ADDENDUM

Date Issued:	April 10, 2019
Project:	Intermountain Healthcare IMC- Cath Lab #6 Remodel 5121 South Cottonwood Street Murray, Utah 84107
Addendum Number:	2

Intermountain Healthcare
IMC- Cath Lab 6 Remodel Project

Demolition Floor Plan- Level 1

A101

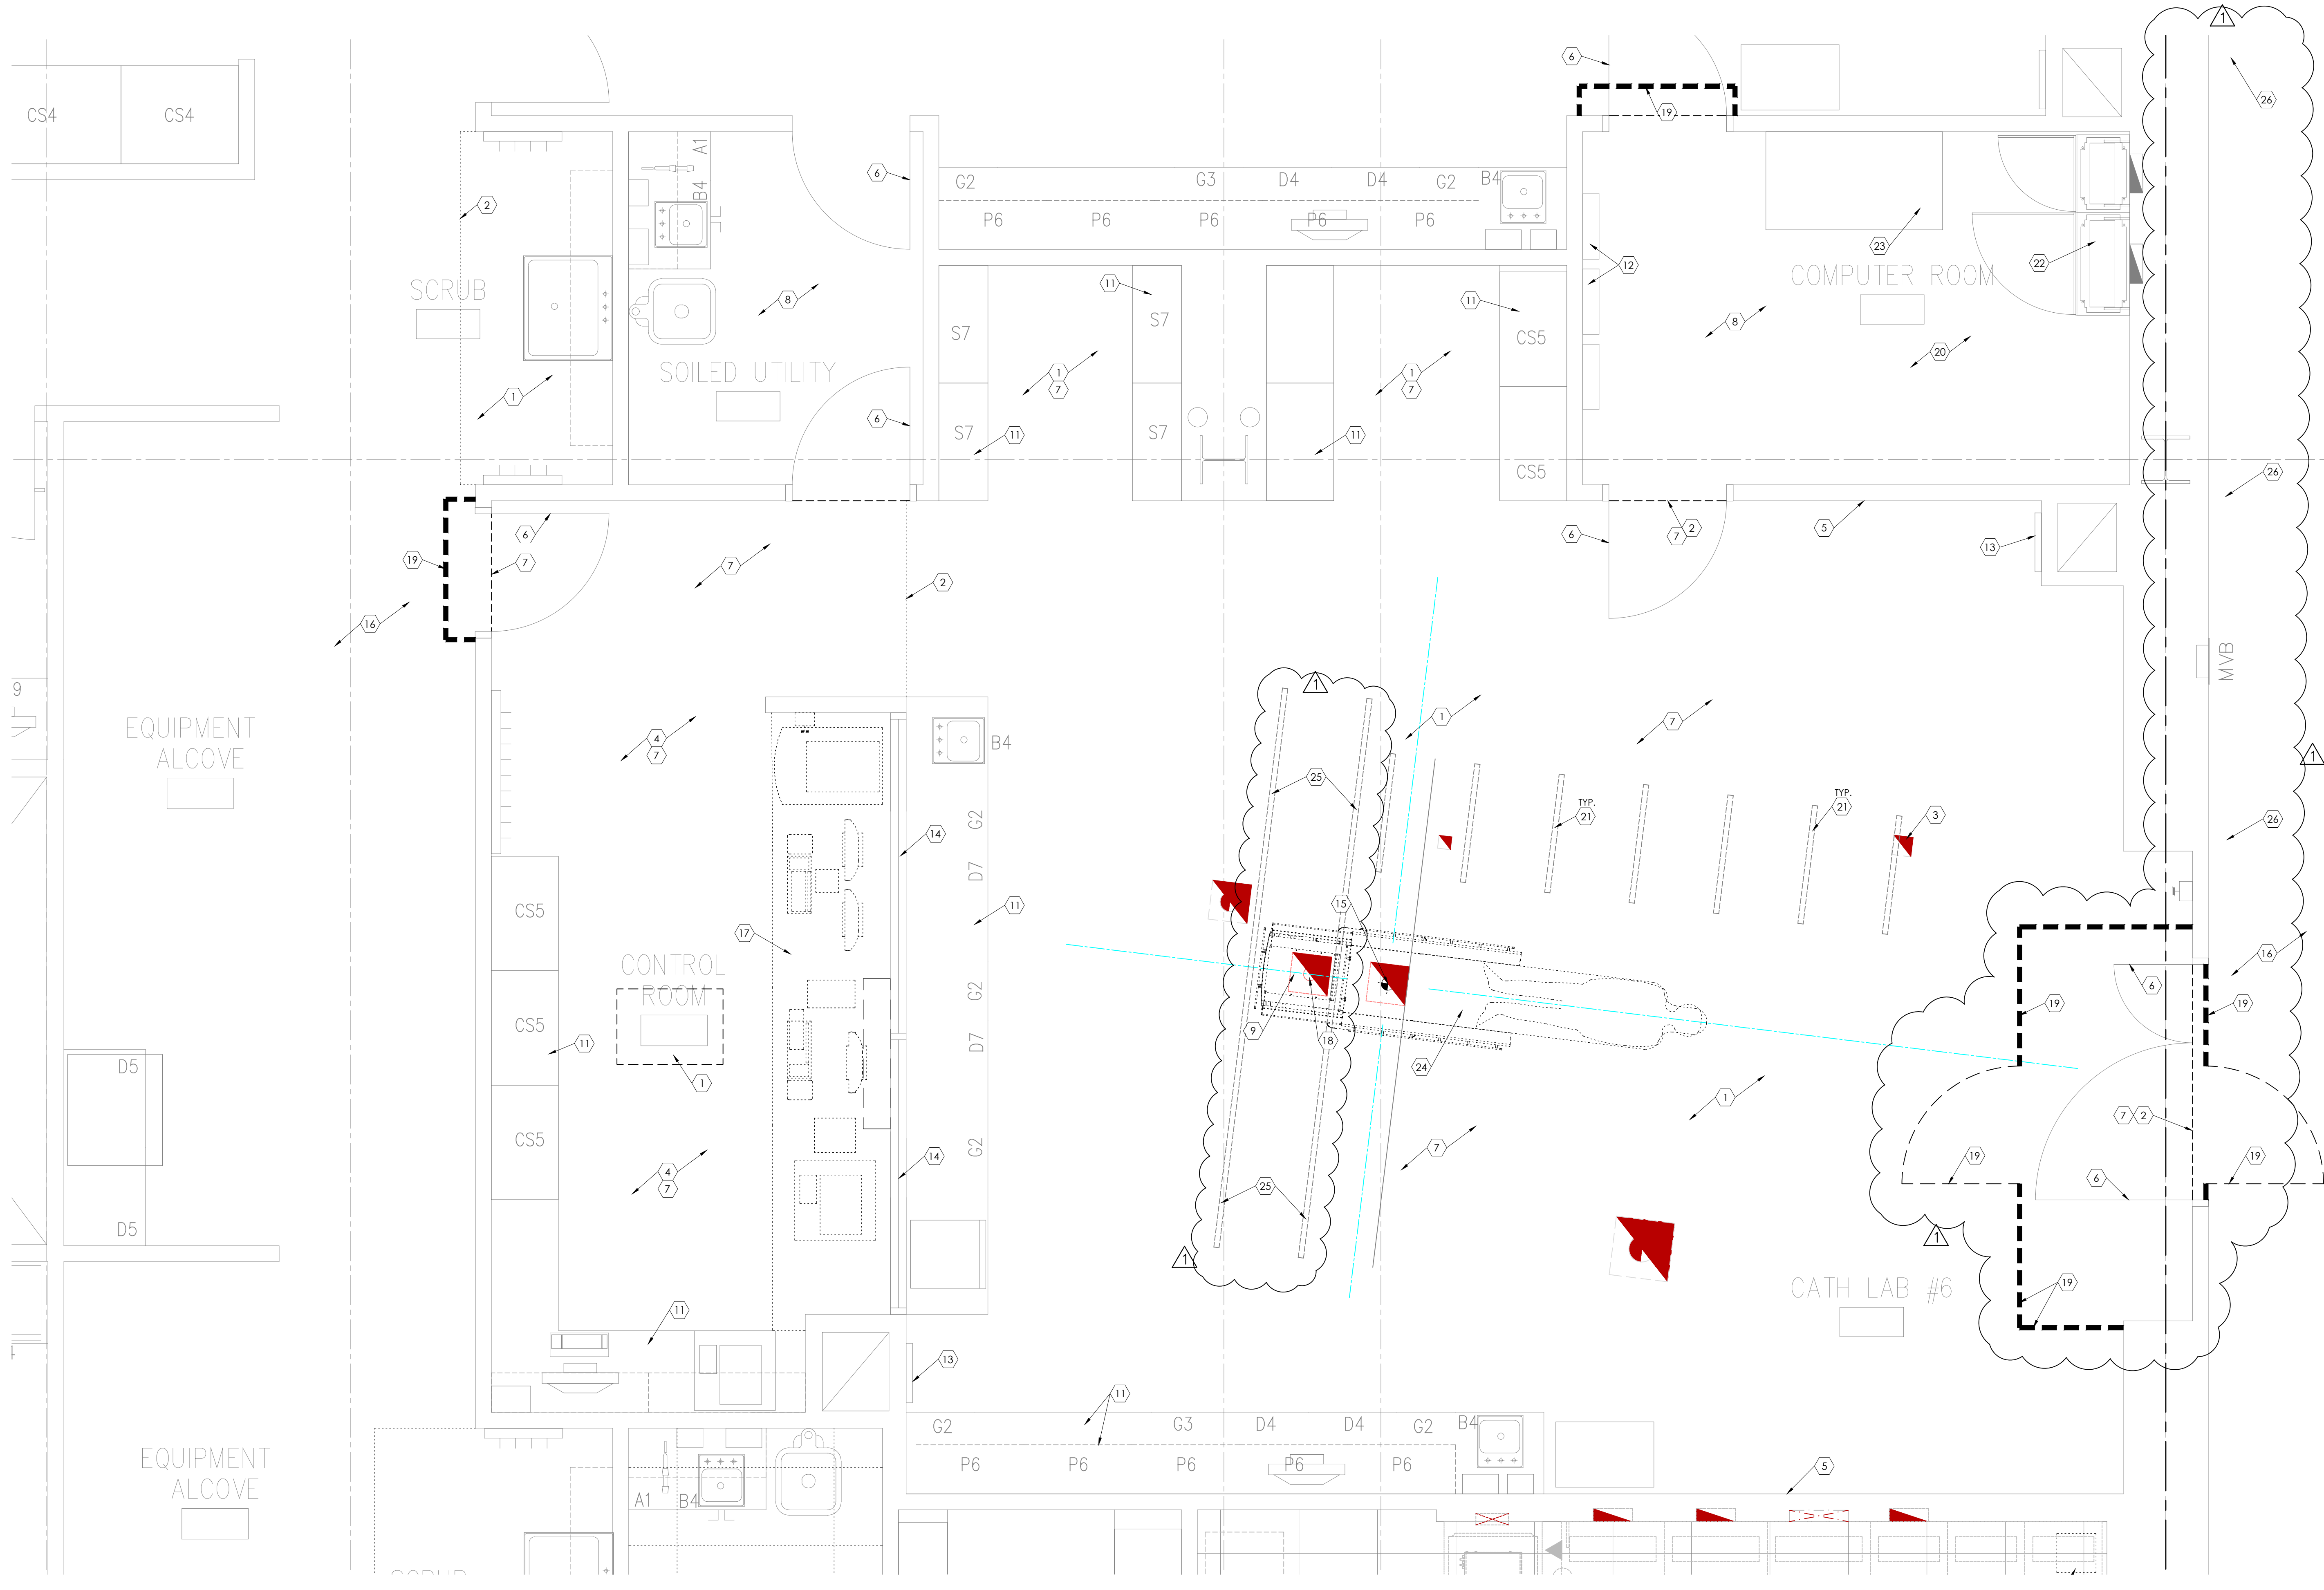
Sheet Number	Drawings
Architectural	
A101	Notes have been added to the demolition plan. See attached revised sheet with revisions shown clouded.
A131	Notes have been added to Reflected ceiling plan. See attached revised sheet with revisions shown clouded.
